UNITED STATES PATENT AND TRADEMARK OFFICE

Office Action Summary

10/552,971

DETAILED ACTION

EXAMINER MARK-UP
NARAYAN et al. FIG. 3

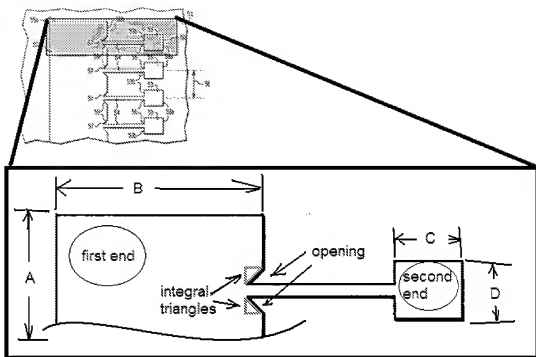
wherein said first end (see Examiner Mark-up Fig. 3: first end) of the metallic material is substantially wider (see Examiner Mark-up Fig. 3: either of

widths A or B) than said second end (see Examiner Mark-up Fig. 3: second end with respect to either of widths C or D) and comprising a plurality of integral triangular-shaped portions (see Examiner Mark-up Fig. 3: integral triangles; while specific term "integral triangles" is not used in this reference, the term is presently considered met by triangular shapes included in, *or integrated* into, the fuse structure, which the mark -up shows) forming openings (see Examiner Mark-up Fig. 3: opening) which face generally toward said second end (see Examiner Mark-up Fig. 3: second end).

Regarding dependent claim 7, Narayan et al. and Marshall et al., as combined, further teach said second end (see Examiner Mark-up Fig. 3: second end) comprises an oblong-shaped portion (see Examiner Mark-up Fig. 3: dimension C appears greater than dimension D).

Regarding dependent claim 14, Narayan et al. and Marshall et al., as combined, further teach said central portion (Narayan Fig. 3: 54; see Marshall et al. Fig. 5A: 203) and said second end (see Examiner Mark-up Fig. 3: second end) form a T-shaped member (the center portion and the second end, as taught by the combination, forms a substantial T-shape).
